# Access Compliance Report

## Public Rights-of-Way (Curb Ramps)

Intersection ID: 24621	Main Street: HUGH_FOREST_RD	Cross Street: WALTHAM_LN	Location: SW
ADA ID: 0D7A058CD290	Ramp Type: PerpDiag	Initial Pass/Fail: Fail	Overall Compliance: No
		Severity Score: 12.5

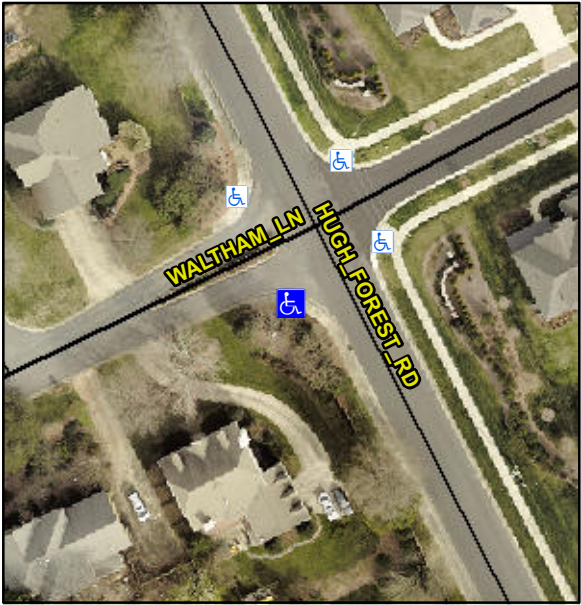
Codes/Mitigation Info/Possible Solution			Field Measurements/Component Compliance		
 <p>Street 1 Name                      <b>HUGH FOREST RD</b></p> <p>Stop Condition-Street 2                      <b>None</b></p> <p>Street 2 Name                      <b>WALTHAM LN</b></p> <p>Stop Condition-Street 1                      <b>StopSign</b></p>	Possible Solutions:		<b>Compliance</b>	<b>Description</b>	<b>Data</b>
	<b>Remove &amp; Replace Curb Ramp With Two New Directional Ramps or Equivalent.</b>		<b>No</b>	Ramp Length (in)	<b>59.5</b>
			<b>Yes</b>	Ramp Width (in)	<b>48.0</b>
			<b>N/A</b>	Flare Type LT	<b>N/A</b>
			<b>N/A</b>	Flare Slope LT (%)	<b>N/A</b>
			<b>N/A</b>	Flare Traversable LT?	<b>N/A</b>
			<b>N/A</b>	Landing Length (in)	<b>N/A</b>
			<b>N/A</b>	Landing Width (in)	<b>N/A</b>
			<b>N/A</b>	Landing Slope (%)	<b>N/A</b>
			<b>N/A</b>	Landing X Slope (%)	<b>N/A</b>
			<b>N/A</b>	Landing Curb? (Y/N)	<b>N/A</b>

<b>N/A</b>	Shared Landing?	<b>N/A</b>
			<b>N/A</b>	Gutter Ponding?	<b>N/A</b>
			<b>N/A</b>	Gutter Lip Ht (in)	<b>N/A</b>
			<b>No</b>	Painted X Walk1?	<b>No</b>
			<b>To E</b>	X Walk 1 Direction	<b>To N</b>
			<b>N/A</b>	X Walk 1 Width (in)	<b>N/A</b>
			<b>1.5</b>	X Walk 1 Slope (%)	<b>2.4</b>
			<b>0.5</b>	X Walk 1 X Slope (%)	<b>2.4</b>
			<b>N/A</b>	Ramp inside XWalk1?	<b>N/A</b>
<p>Surveyor Notes:</p> <p><b>N/A</b></p> <p>PROW/ADA:</p> <p><b>Not Found, R304.2.2</b></p>			<b>N/A</b>	Ramp inside XWalk2?	<b>N/A</b>
			<b>2.4</b>	Road Slope (%)	<b>N/A</b>
			<b>1.7</b>	Road X Slope (%)	<b>N/A</b>
			<b>N/A</b>	Any Obstructions?	<b>N/A</b>
				Obstruction Type	
			<b>N/A</b>		<b>N/A</b>
			<b>Yes</b>	Surface Condition? (G/P)	<b>Good</b>
Total Cost:		\$ 3200.00
